Title: Allow Legacy TBT3 Gen 3 Passive Cables to Operate at Gen 4 Speed in USB4 Mode.

Applied to: USB Type-C Specification Release 2.2, October 2022

Table 5-1 Certified Cables Where USB4-compatible Operation is Expected

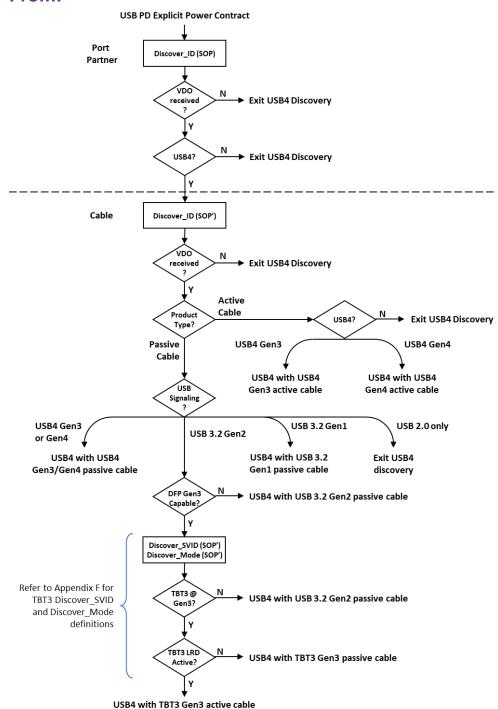
True Thunderbolt 3 Passive Cables marked with TBT3 Gen 3 are practically identical to Passive USB4 Gen3 cables. In the USB Type-C Specification R2.2, with changes to support USB4 V2.0, USB4 Gen3 passive cables were promoted to Gen4 capable, however Table 5-1 still lists that the electrically identical TBT3 Gen 3 cable is limited to 40Gbps instead of 80Gbps. This change will make it clear the true passive TBT3 Gen3 cable is effectively a passive Gen4 USB4 cable, while also explicitly also describing the TBT3 Gen3 active linear redriver cable, which is still limited to 40Gbps.

(a). Table 5-1

TBT3 Gen3 (<u>USB4</u> Gen4)	80 Gbps	In addition to indicating support for <u>USB 3.2</u> Gen2 (010b) in the USB Signaling field of its Passive Cable VDO response, this cable will indicate that it supports TBT3 Gen3 in the Cable Speed parameter and Passive Cable in the Active_Passive parameter of the Discover Mode VDO response. ²
Thunderbolt™ 3 Cables (Active Linear Re-driver)	TBT3 Gen3 (<i>USB4</i> Gen3)	40 Gbps	In addition to indicating support for <i>USB 3.2</i> Gen2 (010b) in the USB Signaling field of its Passive Cable VDO response, this cable will indicate that it supports TBT3 Gen3 in the Cable Speed parameter, and Active Cable in the Active_Passive parameter of the Discover Mode VDO response. ²
USB Type-C Full- Featured Cables (Active) ¹	<u>USB4</u> Gen2	20 Gbps	This cable will indicate support for <u>USB4</u> Gen2 (010b) in the USB Signaling field of its Active Cable VDO response.

- SuperSpeed USB active cables do not support <u>USB4</u>-compatible operation.
 See Appendix F.2.6 and Table F-11 TBT3 Cable Discover Modes VDO Responses
